STATE OF NORTH CAROLINA
DEPARTMENT OF TRANSPORTATION

July 8, 2011

Subject: **Corrected Information to the Neuse Buffer Authorization** for the Rolesville Bypass, US 401 from SR 2044 (Ligon Mill Road) to north of SR 2226 (Jonesville Rd), Wake County, Federal Aid No. STP-401(4), State Project No. 81403001, WBS 34506.1.1, Division 5, TIP R-2814 A.

Rev. 6/7/11
 Buffer Drawing
 Sheet 8 of 9

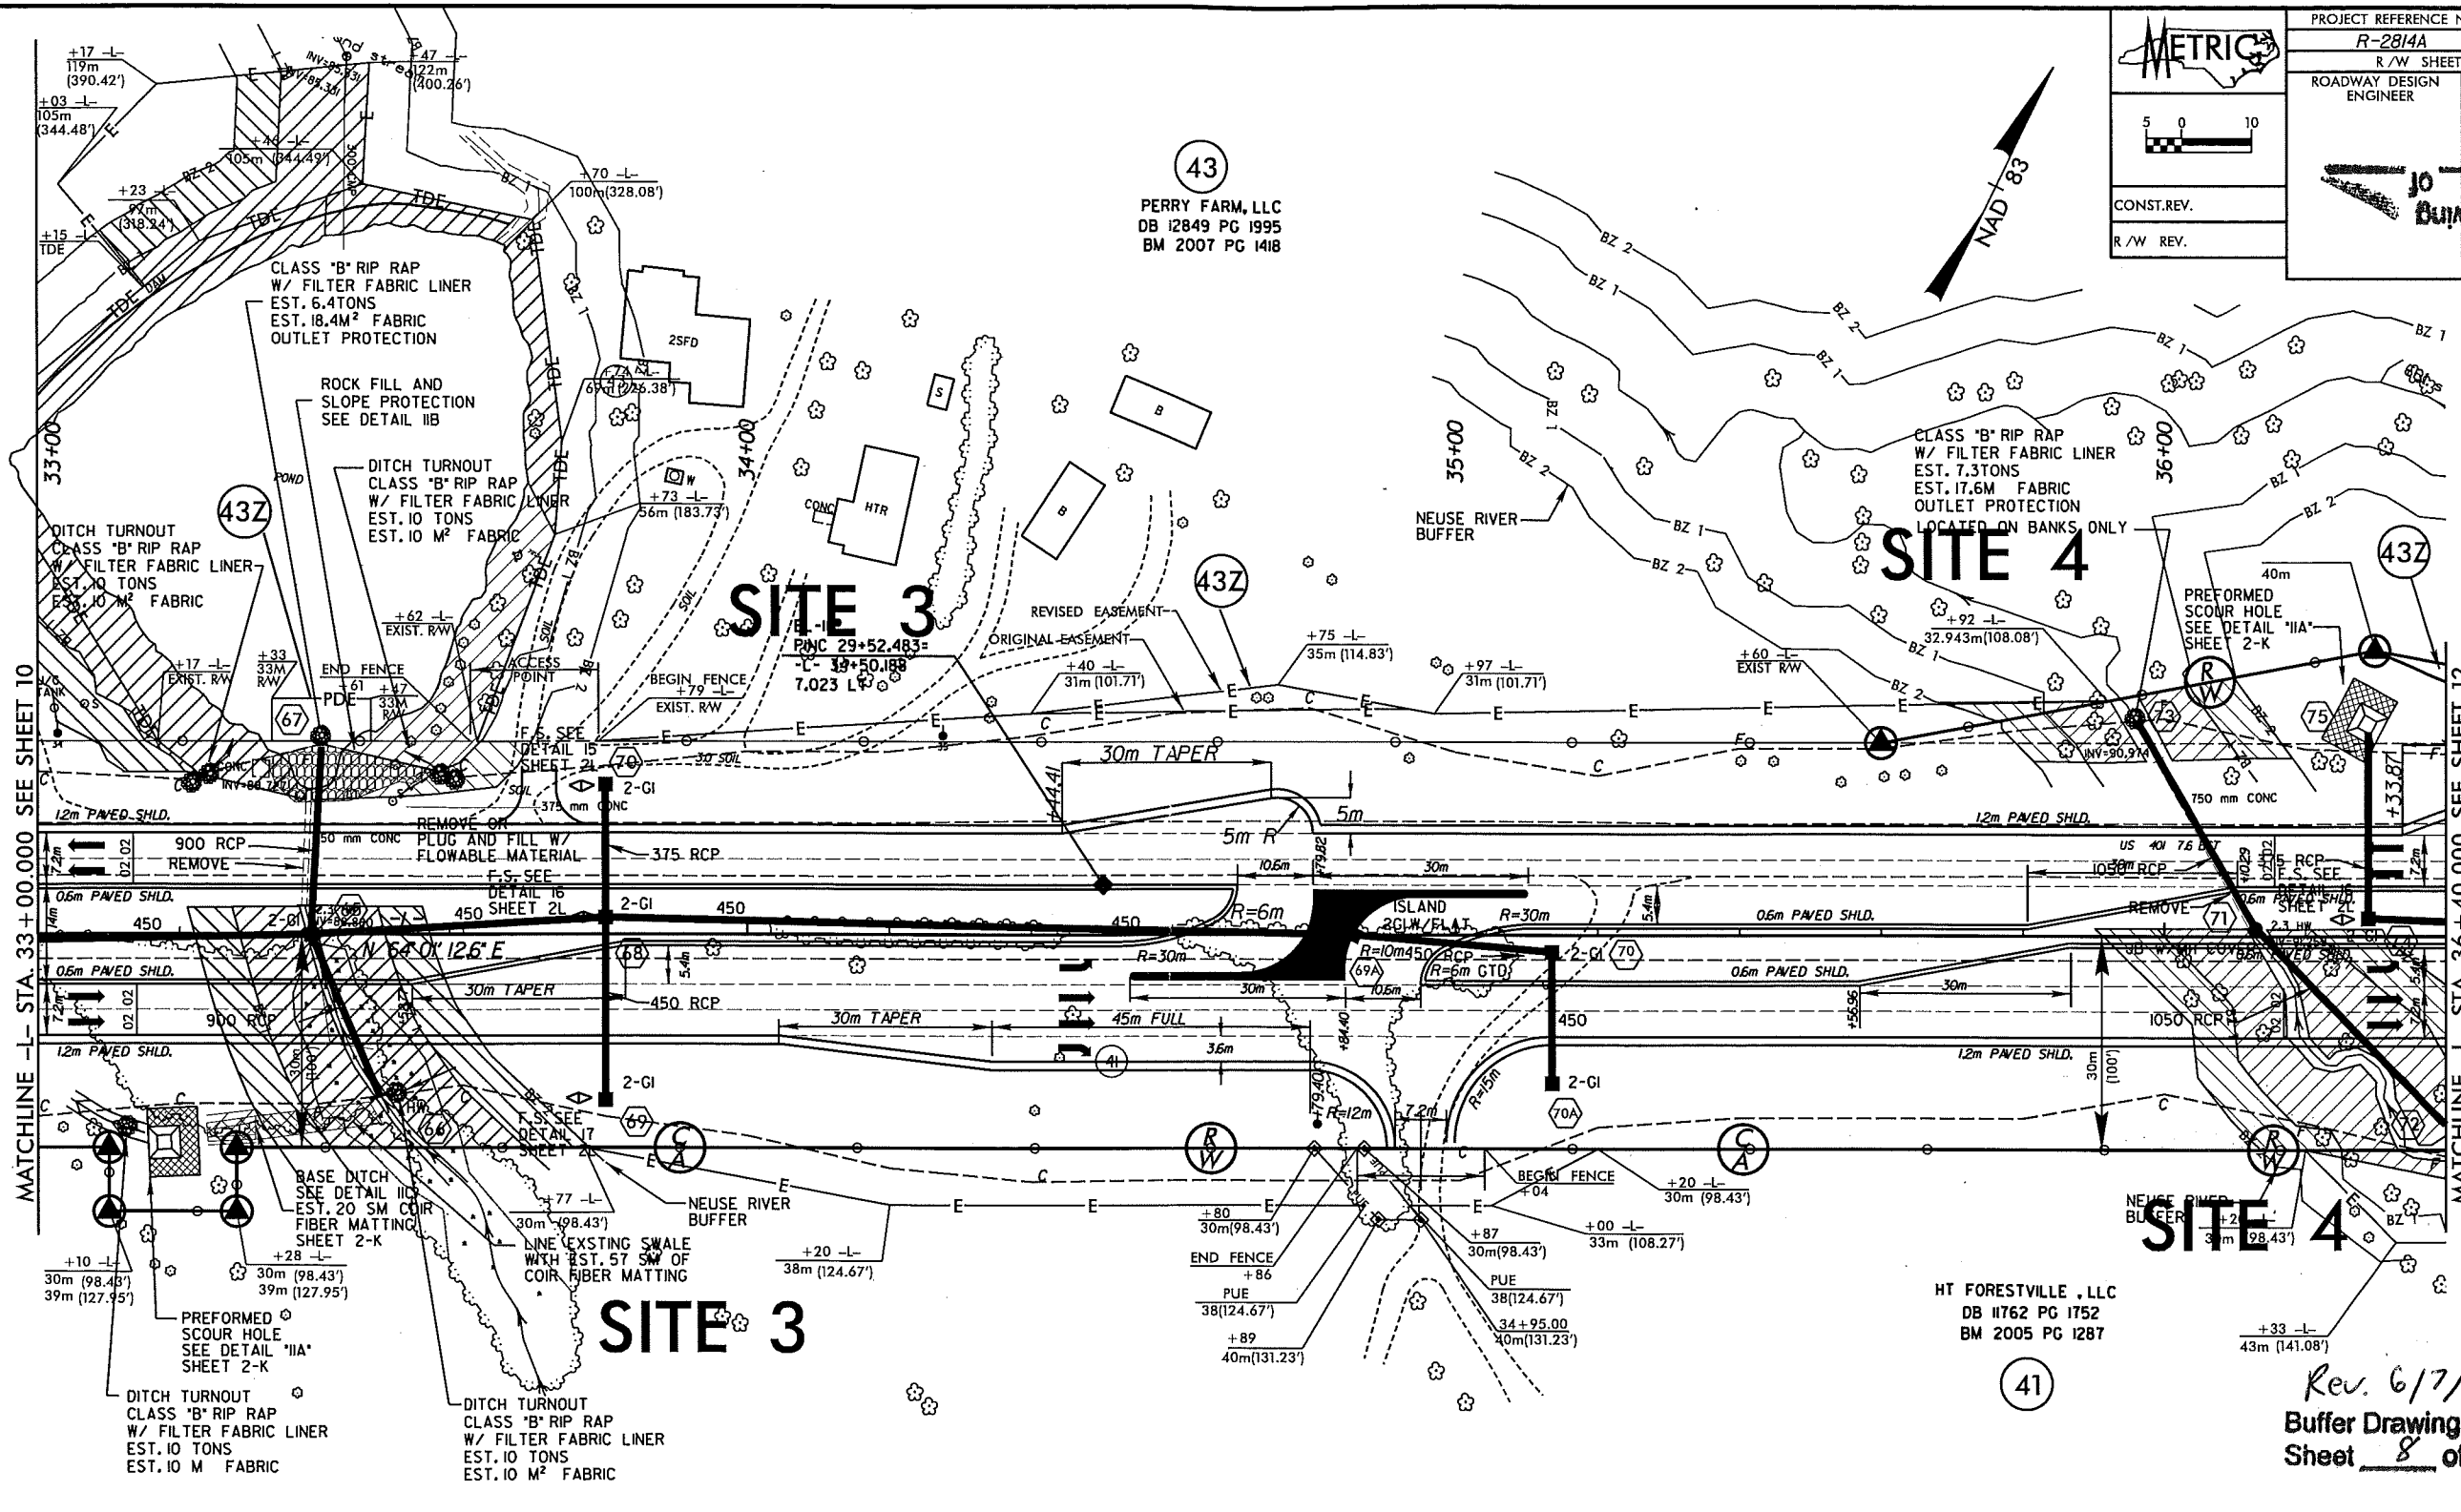
Riparian Buffer Permit Site No. 3

Station 33+24 to 33+30.5 Rt -L-

(see Revised Construction Plan Sheet 2-K and Revised Buffer Permit Drawing 8 of 9)

A pre-formed scour hole (PFSH) has been constructed at Station 33+22 Rt -L-. However, this stormwater device will not properly function due to the existing topography. The area was reviewed by Rob Ridings of the NCDENR-DWQ on April 15, 2011. All parties agreed that a construction revision would be necessary to provide positive drainage from the PFSH. The Department now proposes to construct a base ditch (3:1 side slopes lined with PSRM) at this location that will allow

stable and non-erosive discharge of stormwater runoff through the riparian buffer. This construction revision will not result in additional riparian buffer, stream or wetland impacts.

REVISIONS
 DESIGN REVISION - APRIL 6, 2010
 RW REVISION - APRIL 20, 2010
 CONSTRUCTION REVISION - MAY 11, 2010
 CONSTRUCTION REVISION - MAY 10, 2011
 ADDED ENDWALLS TO PIPES AT STRUCTURE NUMBERS 66 AND 72
 ADDED ENDWALLS TO PERFORMED SCOUR HOLE AT STA. 33+22 ERT -L- SEE DETAIL 2-K
 ADDED BASE DITCH TO PERFORMED SCOUR HOLE AT STA. 33+22 ERT -L- SEE DETAIL 2-K

Rev. 6/7/11
 Buffer Drawing
 Sheet 9 of 9

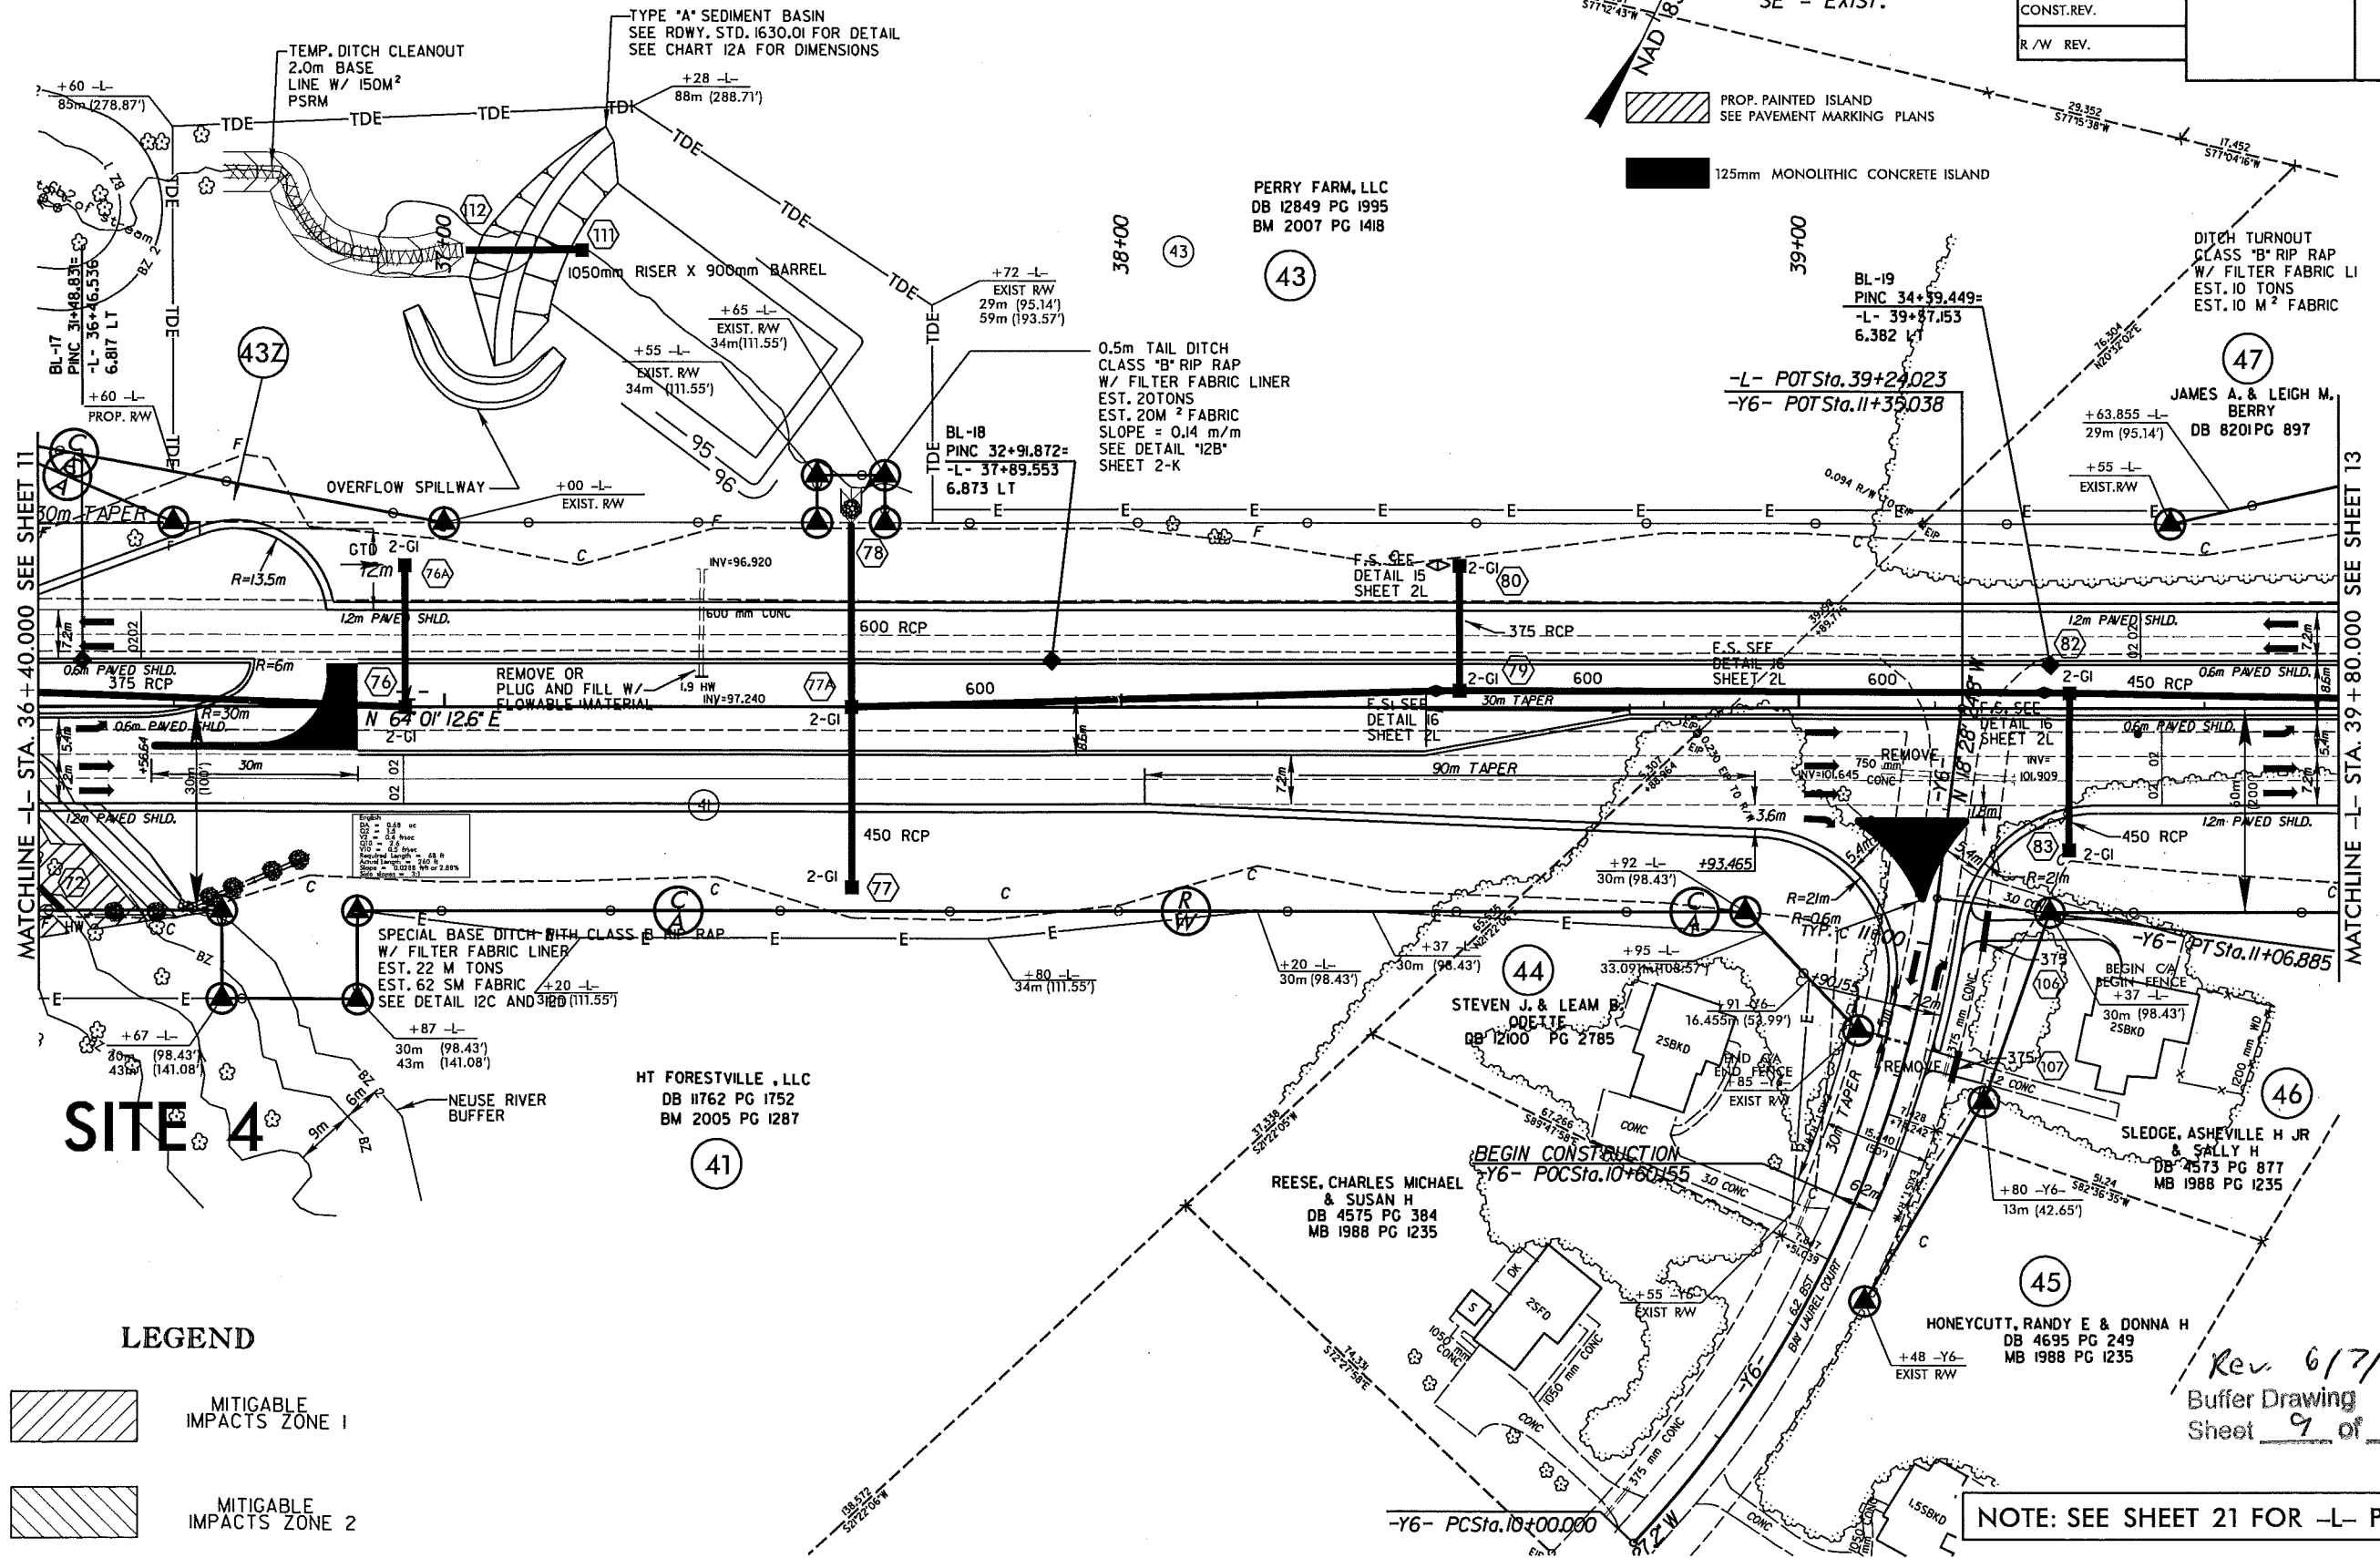
Riparian Buffer Permit Site No. 4

Station 36+47 to 36+80 Rt -L-

(see Revised Construction Plan Sheet 2-K and Revised Buffer Permit Drawing 9 of 9)

A PFSH is proposed to be constructed at Station 33+60 Rt -L-. However, this stormwater device will not properly function due to the existing very steep topography below this proposed device. The area was reviewed by Rob Ridings of the NCDENR-DWQ on April 15, 2011. All parties agreed that a construction revision would be necessary to provide a rip rap lined-feature to transfer stormwater down the steep natural ground to the adjacent channel. The Department now proposes to delete the PFSH and construct a special cut base ditch (3:1 side slopes lined with Class B rip rap) and Special Rock Check Dam at this location that will allow stable and non-erosive discharge of stormwater runoff through the riparian buffer. This construction revision will not result in additional riparian buffer, stream or wetland impacts.

DESIGN REVISION - APRIL 6, 2010
 CONSTRUCTION REVISION - MAY 11, 2010
 CONSTRUCTION REVISION - JUNE 21, 2010 - ADDED ENDWALL TO PIPE AT STRUCTURE NUMBER 72
 CONSTRUCTION REVISION - MAY 10, 2011 - REMOVED PREFORMED SCOUR HOLE AT STA. 36+75 RT -L- AND ADDED 2' BASE DITCH FROM STA. 36+47 TO 36+80 RT -L-
 REVISIONS
